MONTGOMERY COUNTY HISTORIC PRESERVATION COMMISSION
STAFF REPORT

Address: 7019 Eastern Avenue, Takoma Park **Meeting Date:** 10/11/2023
Resource: Contributing Resource **Report Date:** 10/4/2023
 Takoma Park Historic District **Public Notice:** 9/27/2023
Applicant: Sabrina Eaton **Tax Credit:** No
 (Fusion Solar Service, Agent)
Review: HAWP **Staff:** John Liebertz
Permit Number: 1043440
PROPOSAL: Solar panel installation.

STAFF RECOMMENDATION

Staff recommends that the Historic Preservation Commission (HPC) **approve** the HAWP application.

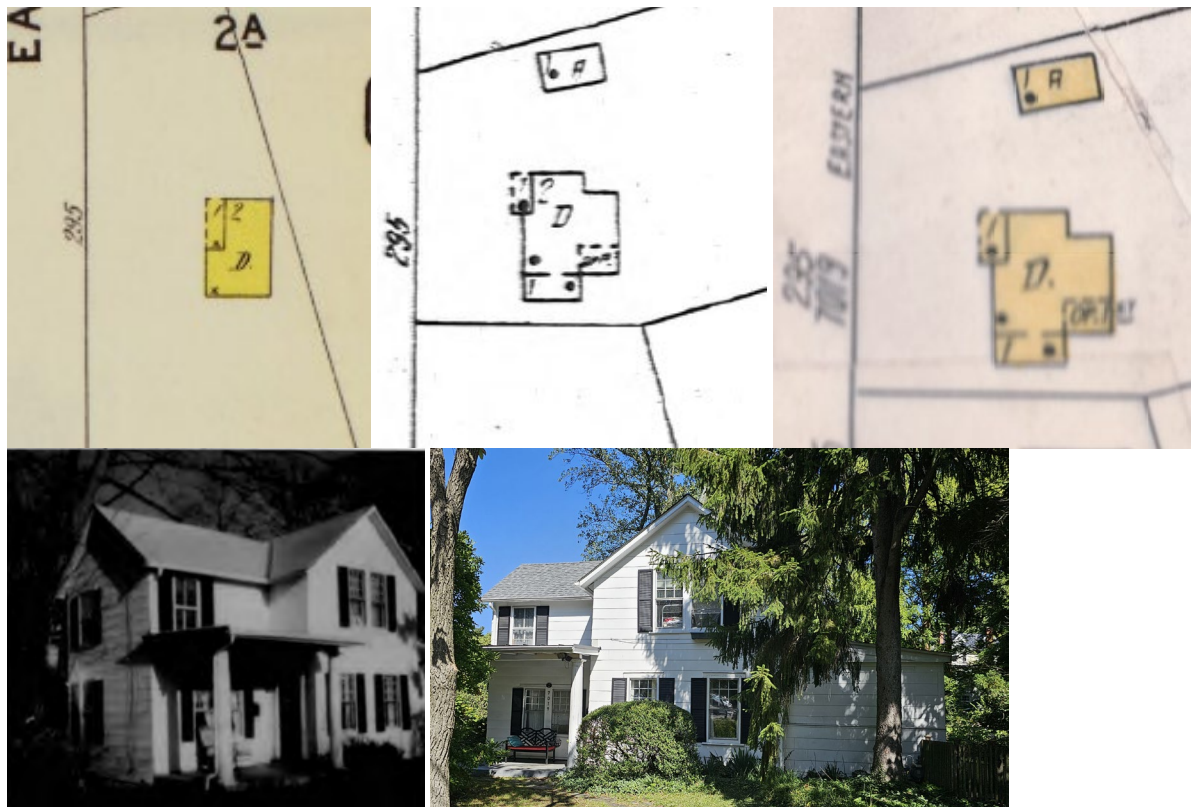
The subject property located mid-block on Eastern Avenue is a Contributing Resource to the Takoma Park Historic District. The site features a vernacular house constructed between 1890 and 1910. The original two-story house consisted of a front-gable with a side-gable ell that created an L-shaped floor plan. The wood-frame house rests on a masonry foundation and is clad with asbestos siding (it is unknown if the original siding remains intact). The façade is adorned with a one-story, wood-frame, shed roof porch supported by Doric columns. Typical fenestration consists of nine-over-one, double-hung, wood-sash windows (*Figure 2*). A 1923 real estate advertisement described the house as follows:

There have been numerous alterations to the form of the house since its initial construction (*Figure 2*). Between 1916 and 1927, the property owners constructed a one-story addition to the south and a two-story addition with an open first-story porch to the east (rear). Other minor alterations occurred at the rear of the house in the twentieth century, but the next major alteration occurred in 2010 when the HPC approved the construction of a two-story rear addition with a screened-in porch.²
